Re: Technical Review
Major Permit Modification
Frey Farm Landfill Vertical Expansion/ Increase in Daily Volumes
Permit No. 101389
Manor Township, Lancaster County

The Department of Environmental Protection (DEP) has completed an initial technical review of the Frey Farm Vertical Expansion application. Please respond to the following comments:

PADEP Phase II Review Figures

Figure 1

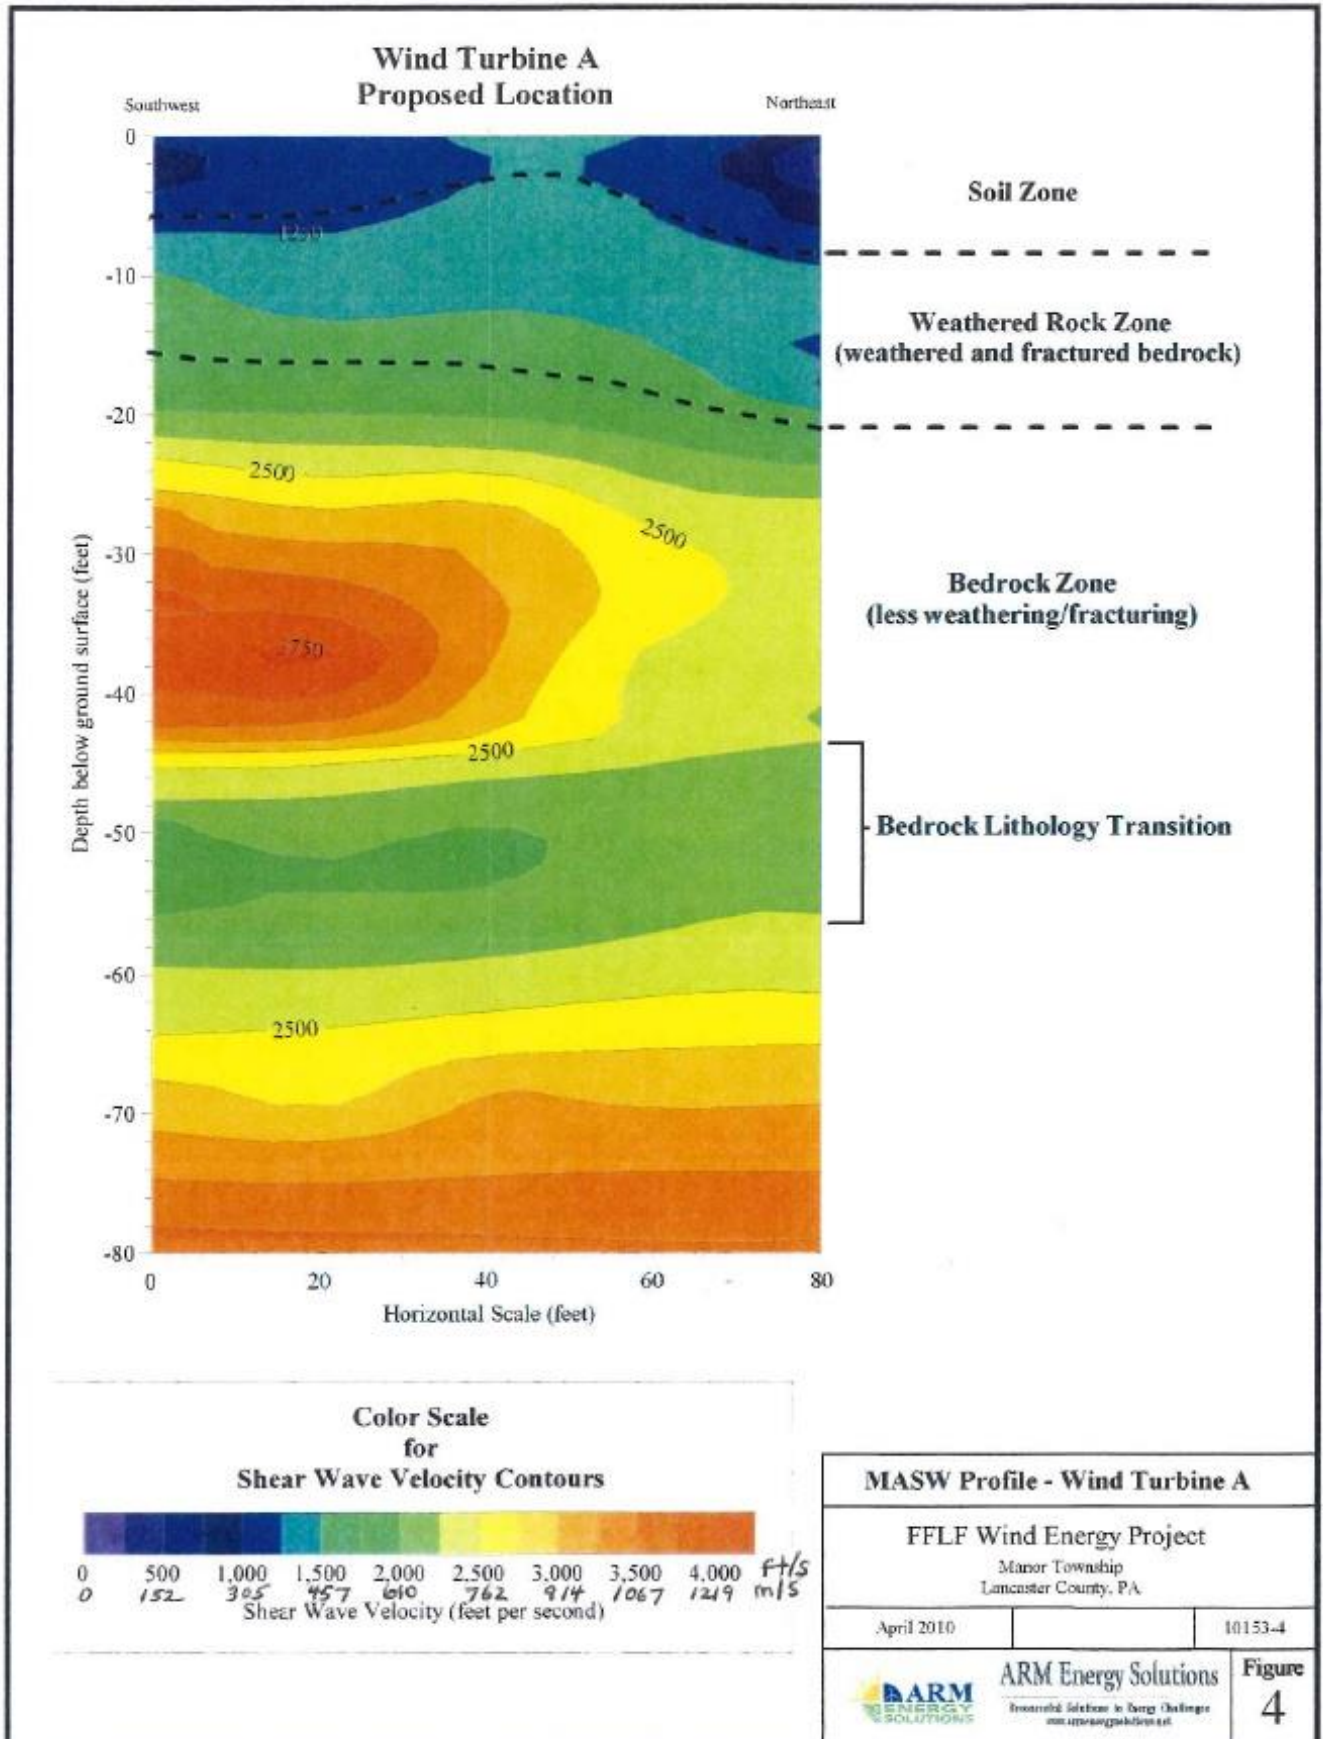
Due to minimal investigation of soils/bedrock in the vicinity of the MSE berm proposed in the area adjacent to the Manor Township Park/Hiking Trail property line, a steep dip slope cliff in close proximity of the Susquehanna River, and in areas of complexly deformed/disturbed bedrock, especially in the vicinity of the circled area on Figure 4, and earlier documented nearby seismic activity, the Department does not agree with ARM's statement: "*We cannot conceive of data that could be collected that would plausibly result in a change to any designed system for environmental protection in connection with the FFVE.*" How can LCSWMA base the proposed MSE berm design in this critical area on only one soil/bedrock sample (e.g. MSEB-26) and softer zones being noted at depth on the April 2010 wind energy project report MASW profiles, as noted on the attached Figure 1 and Figure 2?

- 1) In the vicinity of the northwestern most end of the proposed MSE berm and the adjacent steep dip slope (i.e. underlying disturbed area that is circled on the attached Figure 4 LIDAR map) to help determine if weaker weathered/fractured zones could enhance slip potential in the area due to natural occurrences such as erosion, freeze/thaw cycle, increased seismicity, or other factor(s). Only one soil boring (e.g. MSEB-26) has been documented in this area. As previously noted, softer zones were noted at depth in the April 2010 wind energy project report via the MASW profiles, attached to this review as Figure 1 and Figure 2.

- 4) On the north and northeast sides of the proposed vertical landfill expansion where the proposed ash-filled MSE Berm overlies the major NE-SW trending fracture due to minimal soil boring data in this area and softer zones being documented at depth in the April 2010 wind energy project report via the MASW profiles, attached to this review as Figure 1 and Figure 2.

Figure 3

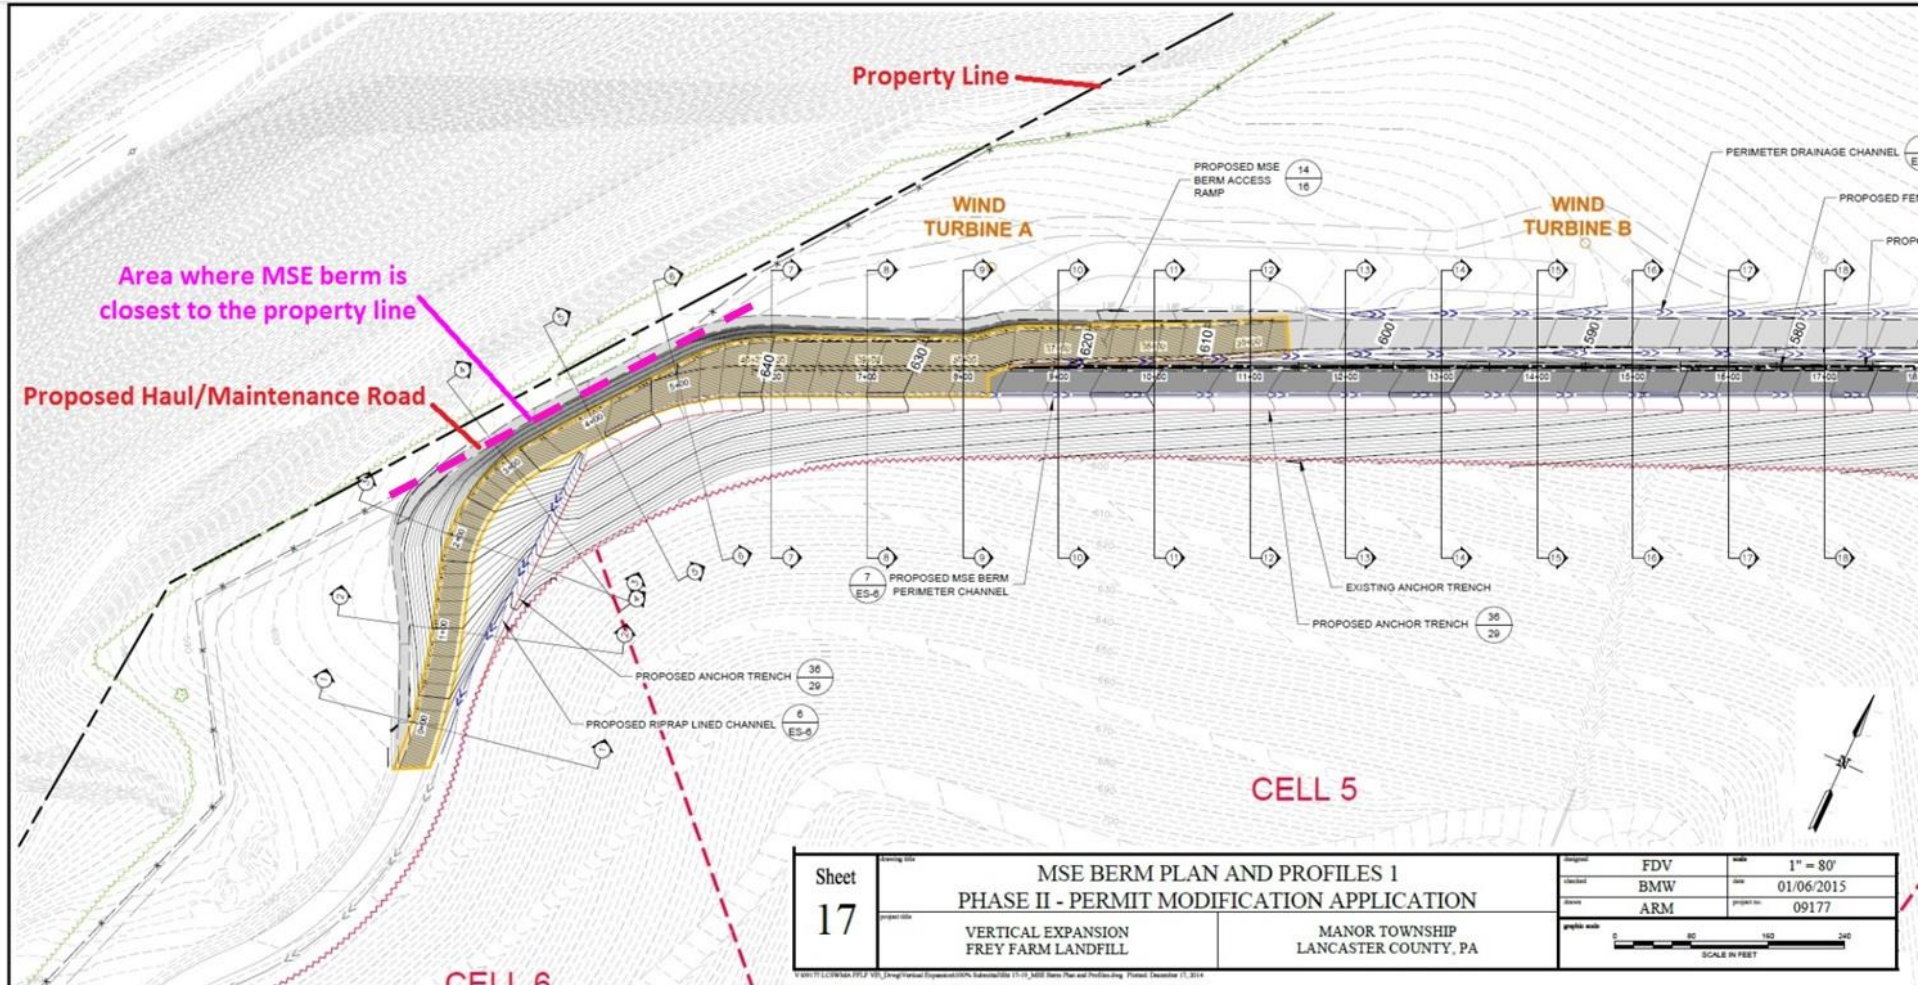
Soil boring MSEB-25, located about 150 feet east of MSEB-26 and in-between Phase II, Sheet 17, Line of Sections 6 and 7 (attached Figure 3), revealed from about 10 to 15 feet BGS the Schist to be highly to completely weathered, very dense, greenish-gray, and dry. From 15 – 25 feet BGS the Schist was greenish-gray, hard, slightly to moderately weathered, no apparent bedding, closely fractured, and RQD (40 – 73%). Water was noted at 13.6 feet BGS.

the 100-year slope stability along the western edge of the landfill be different in the area in-between Phase II, Sheet 17, Line of Sections 3, 4, 5, 6 and 7 (attached [Figure 3](#)), as a result of the MSE berm in this area being parallel to bedrock strike and located near the edge of a steep slope dipping 50 – 90° NW towards the Susquehanna River? As noted on the LIDAR map (attached [Figure 4](#)), there appears to be a possible fracture striking in the NW direction in close proximity to Phase II, Sheet 17, Line of Section 5 (attached [Figure 3](#)). As previously mentioned, only one soil boring (e.g. MSEB-26) has been documented in this area and softer zones were noted at depth on the April 2010 wind energy project report MASW profiles, as noted on the attached [Figure 1](#) and [Figure 2](#). As a result, this area needs to be further studied to verify slope stability due to the closeness of the proposed MSE berm to: the adjacent steep dip slope cliff in close proximity of the Susquehanna River; in areas of complexly deformed bedrock and seismic activity; and being less than 30 feet from the Manor Township Park/Hiking Trail property line and the disturbed area circled on the LIDAR map (attached [Figure 4](#)). Additionally, the outside/adjacent haul/maintenance road is even closer, less than 20 feet from the Manor Township Park/Hiking Trail property line and the circled disturbed area on the LIDAR map (attached [Figure 4](#)).

Figure 4

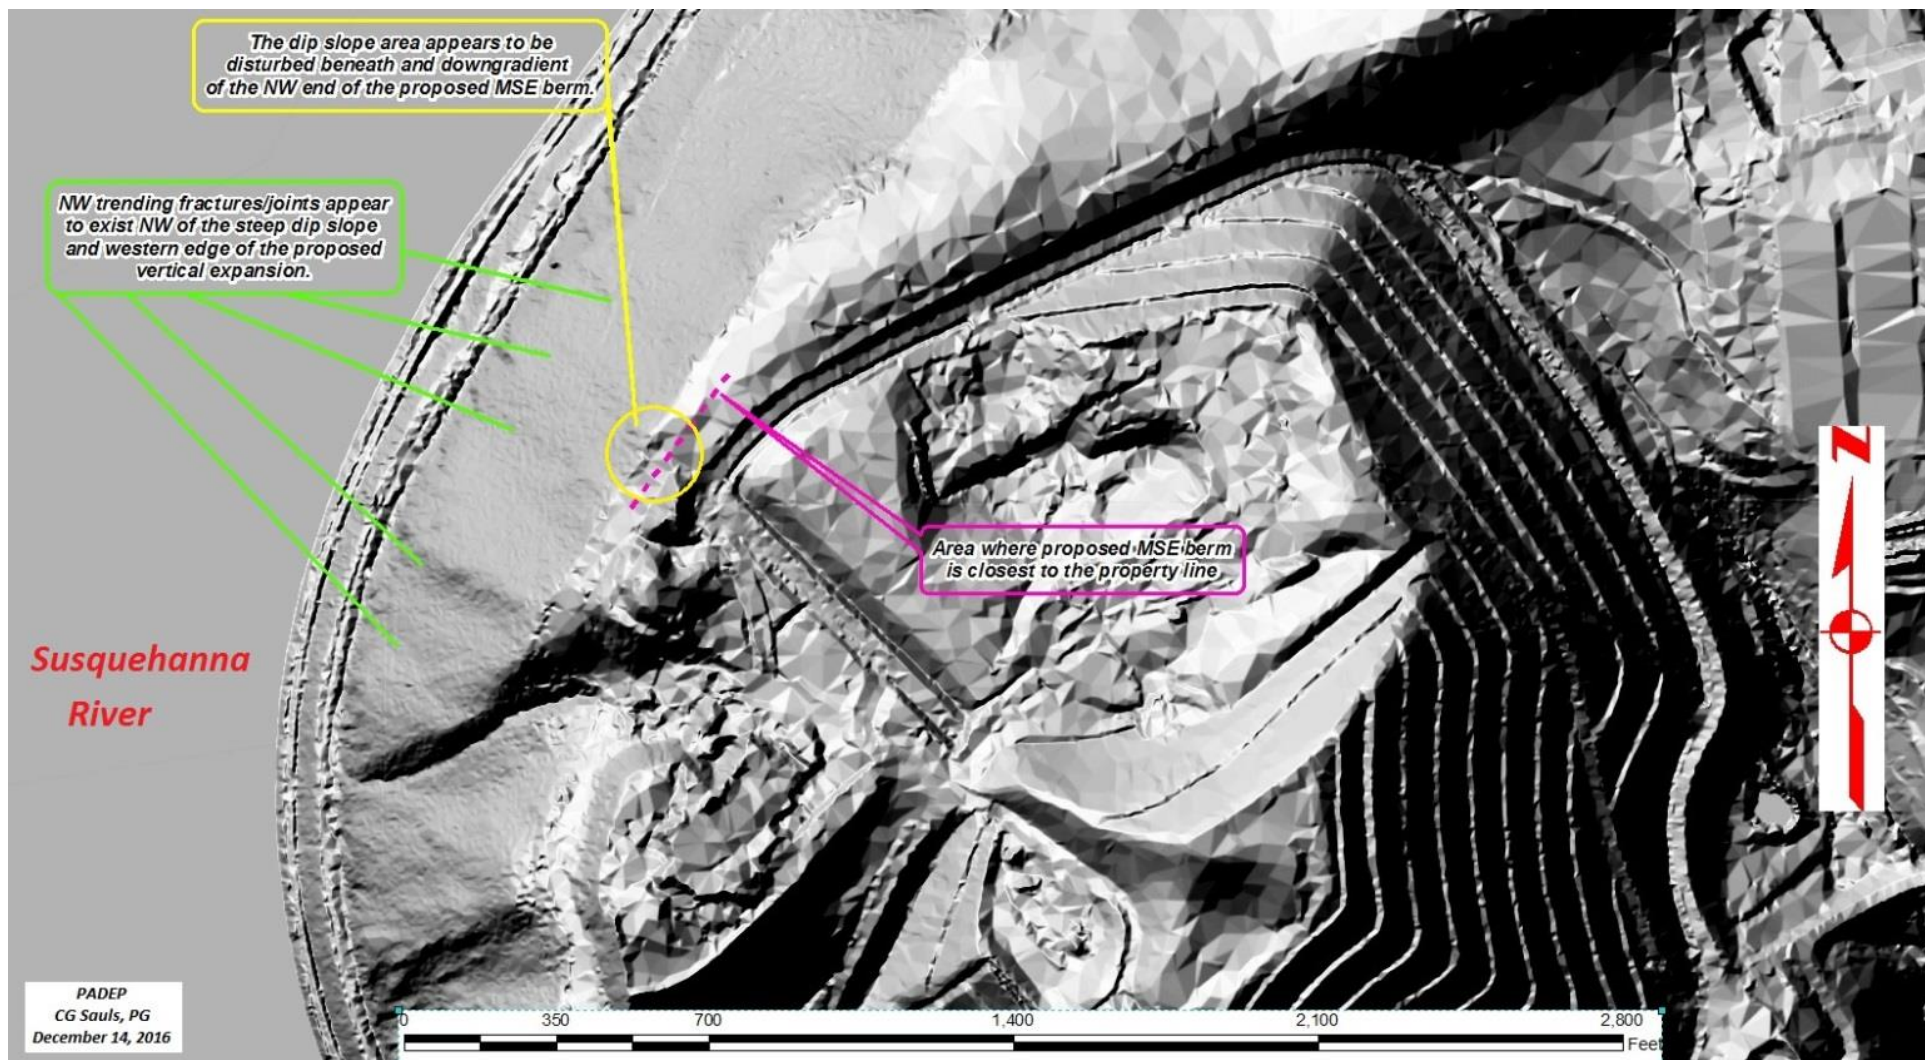
- 2) As noted on the inserted enhanced LIDAR map (attached Figure 4), there appears to be earth disturbance (circled area) beneath the proposed MSE berm area closest to the Manor Township Park/Hiking Trail property line in the vicinity of Phase II, Sheet 17, Line of Section 5. Could this be related to erosional weathering of the underlying fractured/jointed bedrock? A major NE-SW trending fracture extends through this area in addition to a smaller possible NW-SE trending fracture as noted on the LIDAR map (attached Figure 4).

The soil filled MSE Berm in this area will be as close as 30 feet and the adjacent haul/maintenance road as close as 20 feet from the property line and overlying the disturbed area circled on the LIDAR map (attached [Figure 4](#)). As noted on Page 5 of the September 23, 2016 document submitted by Yoder, *“...if there is a problem with the MSE wall, the liner or even storm water runoff, the 15-20’ of setback from the base of the MSE berm to the property line would make it virtually impossible to maneuver the type of large equipment necessary to address such problems. Worse yet, should some type of failure occur, waste and ash would cascade over the edge of Turkey Hill point down into the Susquehanna River. Due to limited setback and the existence of steep slopes, cleaning up such an accident would be impossible and lead to an environmental catastrophe.”* Additionally, Recommendation #6 of the September 16, 2016 expert document (Benson) suggests that, *“A deformation analysis should be conducted to evaluate movement of the MSE wall and translation of the waste should a static or seismic failure occur. This analysis should evaluate whether the existing and proposed setbacks are sufficient to contain the waste should a failure occur.”* In the event of a cap slide, membrane slide, or other issue, is there sufficient setback distance on top of Turkey Hill to maneuver heavy equipment for remediation purposes?
